# Preliminary Change Request for the Powering of the 21Q40 and 26Q40 Focusing Arc Quadrupoles

***Preliminary Change Request for the powering  
Of the 21Q40 and 26Q40 focusing arc quadrupoles***

BNL/SNS TECHNICAL NOTE

NO. 092

Figure 3: Optics functions (top) and beta and dispersion beating [2] (bottom) after including a 1 % systematic error in the quadrupole strengths of the large bore arc quadrupoles, for a lattice matched to the working point (6.40,6.30).

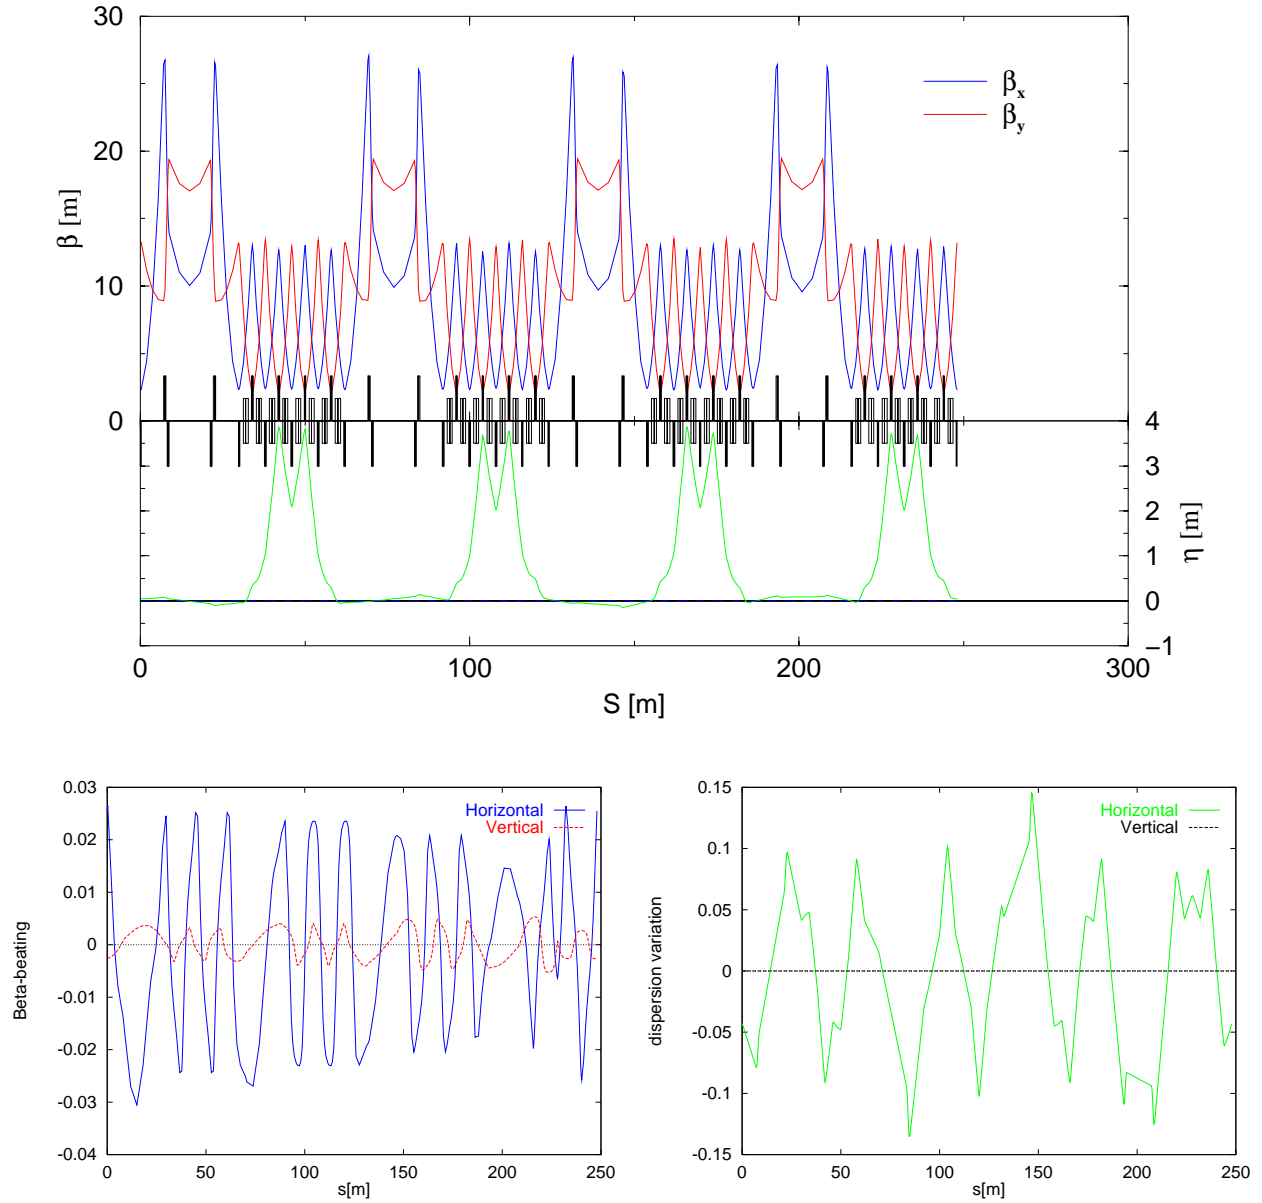
This systematic error in the quadrupole field can introduce significant optics distortion especially because these quadrupoles are located in areas of maximum dispersion. This can be observed in Fig. 3 where we plot the lattice function for all four super-periods and the associated beta and dispersion perturbation, when a 1 % error is introduced in the gradient

of the high-dispersion large bore quadrupoles. Even after re-matching the lattice, there is a variation of the horizontal beta function of up to  $\pm 3\%$ , especially in the straight sections. The dispersion has a variation of up to  $\pm 10\%$ . Especially the straight sections are not dispersion free due to this error. One can note also that the super-periodicity of the lattice is broken. This is mostly pronounced in the horizontal beta function of the straight sections and the dispersion in the middle of the arc.

Thus, a different option was considered, where the 26Q40 quadrupoles are powered independently of the 21Q40 quads. The latter would necessitate the purchase of two same size medium power supplies. This option is much more robust than the previous one as it would solve both the gradient perturbation and the magnetic field quality problems. It would also simplify the mechanical design of the magnet by removing the additional TRIM winding. Finally, the number of cables for connecting the TRIM windings will be further reduced.

The powering scheme of the focusing arc quadrupoles with different bore radius was reviewed. It was found that the preferable scheme for physics, cost and schedule issues would be to connect the different type of quadrupoles with 2 medium power supplies instead of the initial connection scheme with one high power supply and an additional TRIM winding,
